REALIGNMENT OF US 460

MENIFEE COUNTY

VALUE ENGINEERING TEAM #6

Value Engineering - Study Identification

PROPOSAL #1

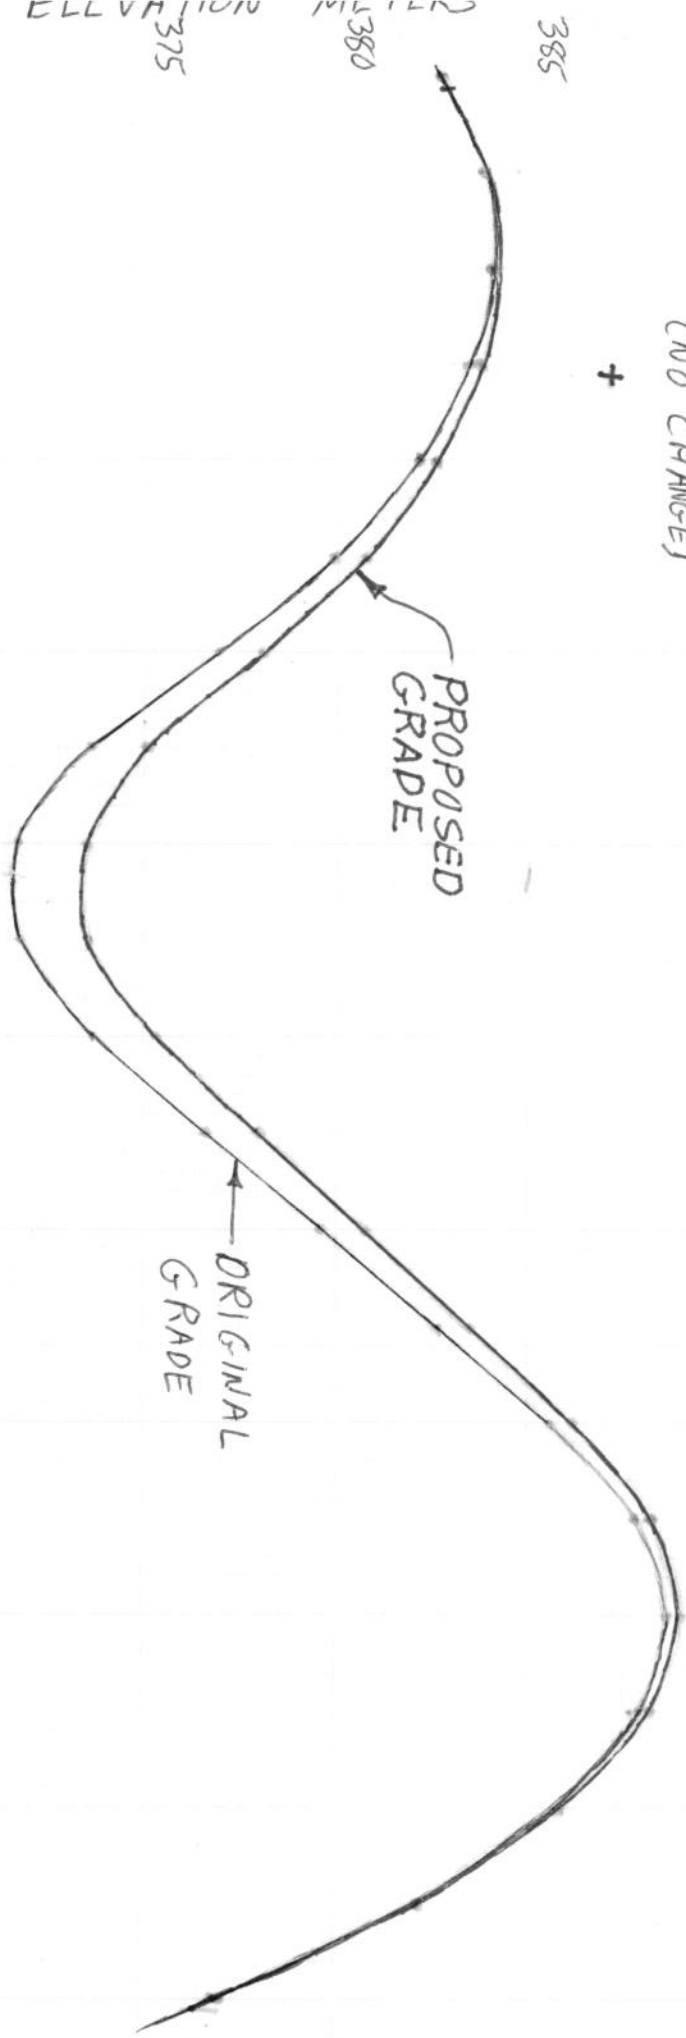
THIS PROPOSAL WILL RAISE THE PLAN GRADE FOR 2000 METERS IN A VERTICAL SAG, BETWEEN STA 71+800 AND STA 73+800. THE PVI IN THE SAG AT STA 72+634 IS RAISED 2 METERS WITH NO CHANGE TO THE CREST PVI'S AT STA 72+113 AND STA 73+507. THE RESULT IS A MAXIMUM GRADE RAISE OF 1.75 METERS AT STATION 72+700. THIS RESULTS IN A 40,000 CUBIC METER ROADWAY EXCAVATION REDUCTION.

THIS PROPOSAL RECOMMENDS RAISING THE P.I. @ STA 72+634 FROM 368.792 TO 370.792. THE P.I.'S AT STA 72+113 AND STA 73+507 WILL BE UNCHANGED. RAISING THE GRADE WILL REDUCE THE ROADWAY EXCAVATION BY 40,000 CUBIC METERS. THE WASTE WILL BE REDUCED BY 70,000 CUBIC METERS IN THAT AN ADDITIONAL 30,000 CUBIC METERS WILL BE USED FOR FILL.
